Office Action Summary	Application No. 10/563,886	Applicant(s) KESKI-NISULA, KATRI	
	Examiner YOGESH P. PATEL	Art Unit 4111

DETAILED ACTION

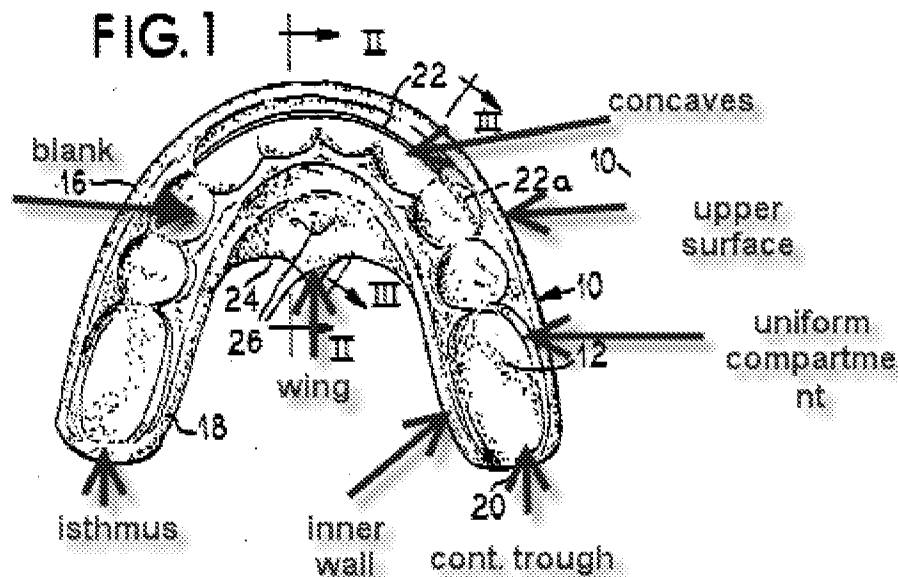
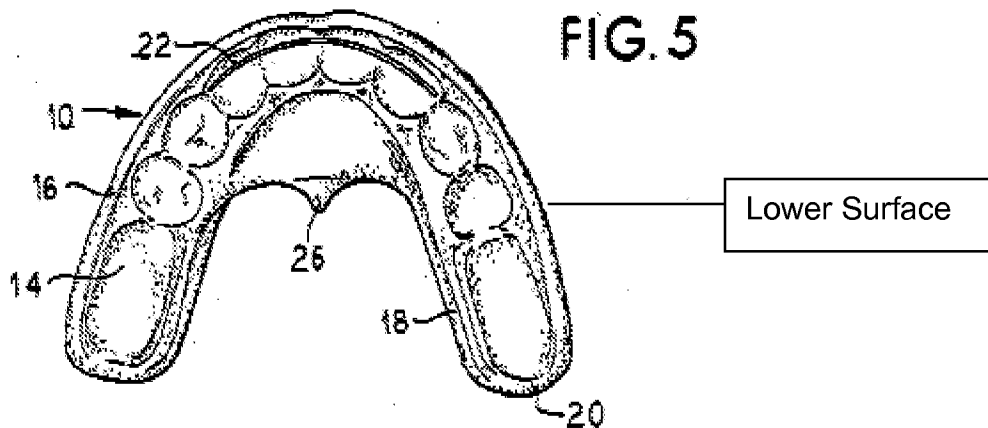
21. Claims 1-5 are rejected under 35 U.S.C. 102(b) as being anticipated by Bergersen (Pat. 4,784,605).

Regarding claim 1, Bergersen discloses an odontological device including a generally U-shaped arch that has a lower surface on the lower jaw side and an upper surface on the upper jaw side, and concaves forming an isthmus separating the concaves and the walls of the concaves are formed by the outer walls on the labial or buccal side, respectively, and of inner walls arranged on the opposite sides of the concaves on the lingual side of the tongue; the isthmus between the concaves having recesses, a part of which are meant for individual teeth, wherein the recesses consist of uniform compartments, which start from the second premolar and continue towards the molars at least partially to the area where the second permanent molar will erupt (see the figures below). Regarding claim 2, Bergersen discloses uniform compartments that are

formed by outer and correspondingly inner walls, which have essentially straight walls (see figures below). Regarding claim 3, Bergersen discloses the uniform compartments are shaped like continuous troughs 12, and the troughs are open from the molar side end (see the figures below). Regarding claim 4 Bergersen discloses the recesses contain limited to the area of the front teeth, and the walls of the recesses are essentially smooth-surfaced (col. 2, lines 35-40). Regarding claim 5, Bergersen discloses the concaves have their own blanks for canine teeth and the first premolars (see the figures below).

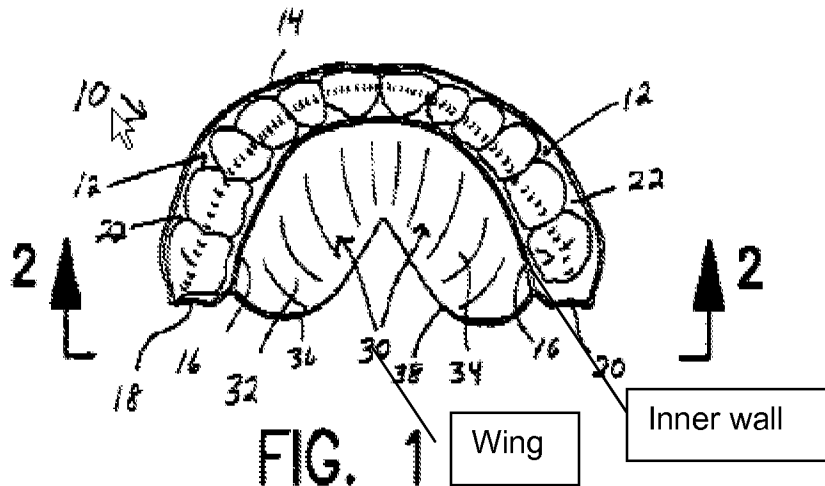
Bergersen '420 teaches many arrangements may be incorporated in a dental appliance to address different problems by varying the thickness of the isthmus (col. 6, lines 49-57). For example, for overbite corrections, a thickness of the isthmus increases at the anterior region relative to the posterior region as compared with the normal occlusion

design would optimally be between 4 to 5 mm thereby causing the anterior teeth to be depressed 1 to 2 mm before contact of the posterior teeth is possible. Similarly, by increasing the thickness of the isthmus in the posterior region relative to the anterior region, an open bite can be corrected. The variation in thickness of the isthmus is occurs in step because the thickness is different in anterior and posterior portions. It would have been obvious to a person of ordinary skill in the art at the time of the invention was made to have provided a varying thickness of the isthmus of the device as taught by Bergersen'420 to the orthodontic device of Bergersen to correct open bite and overbite problems (col. 6, lines 49-67 and col. 7, lines 19-42).
